Safety Review and Confirmatory Analysis

Entergy's 10 CFR 50.59 Safety Evaluation

Algonquin Incremental Market (AIM)

Project Indian Point Energy Center (IPEC)

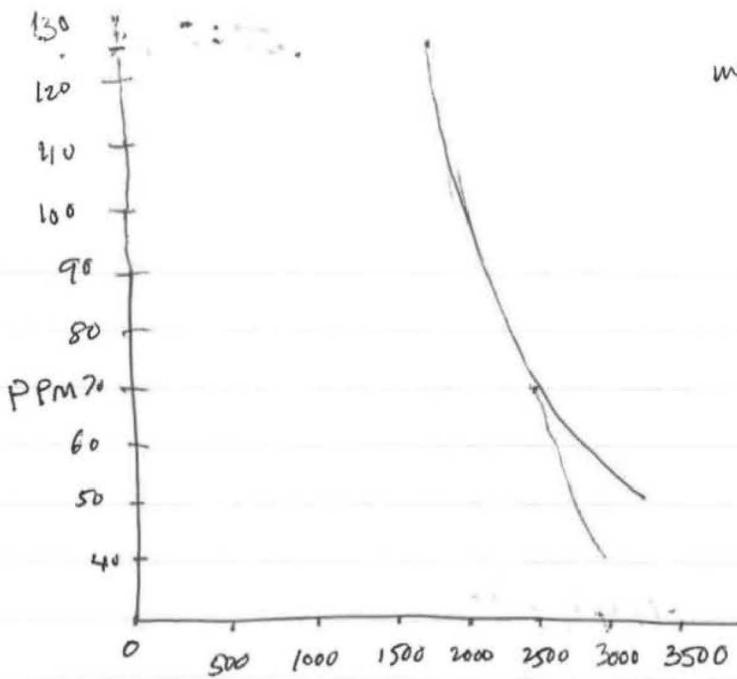
③ For the closest distance from enhanced pipeline, ~~it is assumed that~~ due to higher depth of pipeline, additional concrete blocks on top of the buried pipeline and other engineering features, it is assumed that the 1min release is further held up and only (b)(7)(F) is released to atmosphere. Based on this assumption ALOHA Num is made to calculate the minimum safe distance.

Since the closest distance from enhanced pipeline to SOCA ~~is 500ft~~ (b)(7)(F) 1500ft, and if SSC about 100ft from SOCA it can be concluded that the minimum safe distance ^{not exceeding 1PSi overpres} determined will ~~not~~ be met and ^{there will be} no adverse impact on the safe operation of the plant.
